DEPARTMENT OF TRANSPORTATION

[Docket No. FAA-2020-0883; Project Identifier 2019-CE-034-AD]

Airworthiness Directives; Rockwell Collins, Inc. Flight Display System Application

ACTION: Notice of proposed rulemaking (NPRM).

Figure 1 to paragraph (g)(1)(iii); placard location on bezel

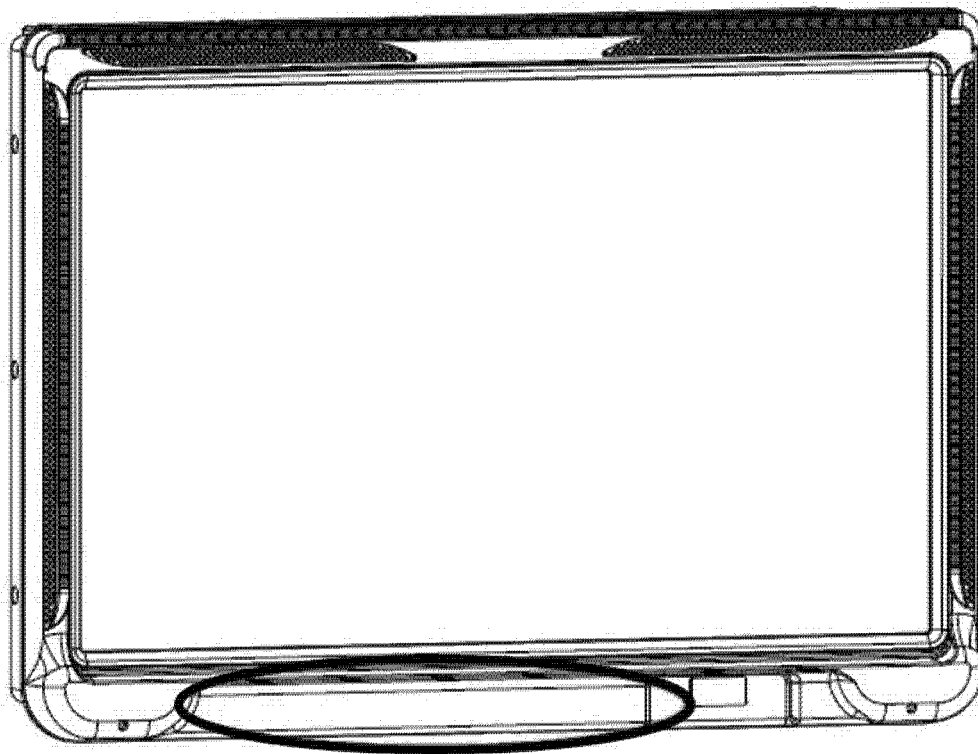
(ii) Fabricate a placard for each aircraft primary flight display, using at least 1/8 inch letters, with the following text: TCAS Flight Ops—TA Only mode (TA/RA mode prohibited).

(iii) Install the placard on the bottom of each aircraft primary flight display bezel in the area depicted in figure 1 to paragraph (g)(1)(iii) of this AD.

(4) The airplane flight manual revision and placards required by paragraph (g)(1) of this AD may be removed after completing the software upgrade required by paragraph (g)(3) of this AD.
